**ADDENDUM NO. 06**

**Date: 08.16.2024**

**Westfield Washington School Corporation  
Westfield Middle School West  
Bid Package 02, BI:02 Building Concrete Work and BI:03 Steel and Railing Work  
17707 Centennial Road,  
Westfield, IN. 46074**

This Addendum #06, Dated 08.16.2024, forms part of the contract documents and modifies the original Bidding Documents Dated 07.26.2024. Please acknowledge receipt of this Addendum in the space provided on the Bid Form. Failure to acknowledge this Addendum may subject the Bidder to disqualification.

4 ENLARGED RAILING DETAIL  
SCALE: 1" = 1'-0"

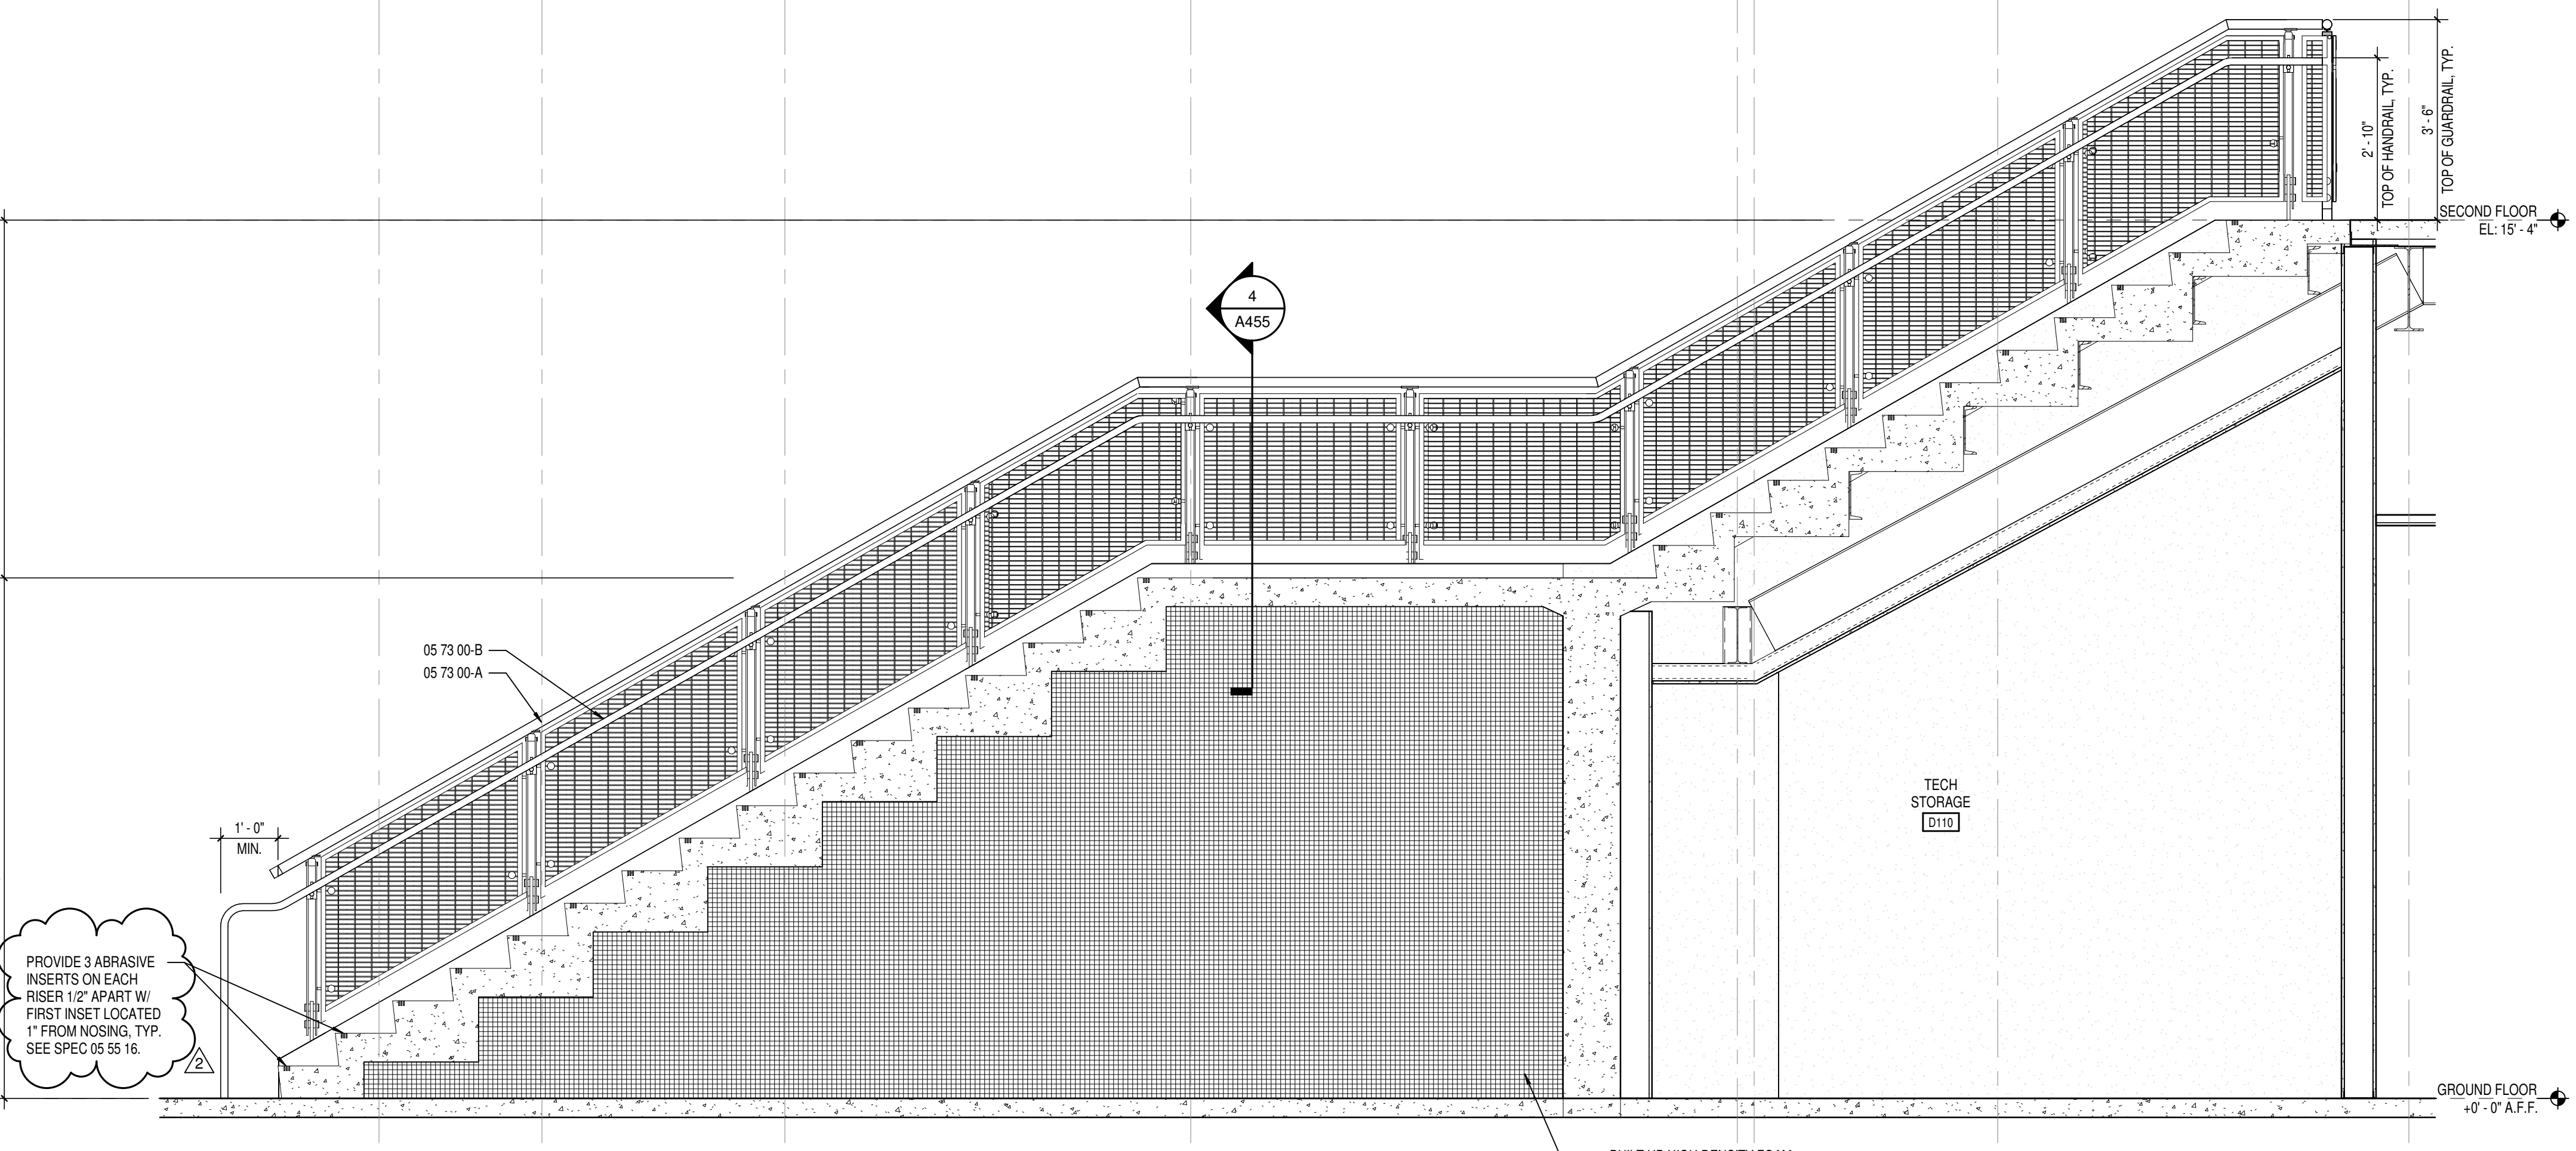
10. Bid Item #02 Building Concrete Contractor shall furnish and install the Stair Nosings per Spec Section 05 55 16 to the Stair per the Detail 1/A455.

A. Detail 1/A455 - STAIR ST105 SECTION B- SOUTH

B. Detail 2/A455 – STAIR ST105 ENLARGED GROUND FLOOR PLAN

C. Detail 3/A455 – STAIR ST105 ENLARGED SECOND FLOOR PLAN

D. Detail 4/A455 – ENLARGED RAILING DETAIL
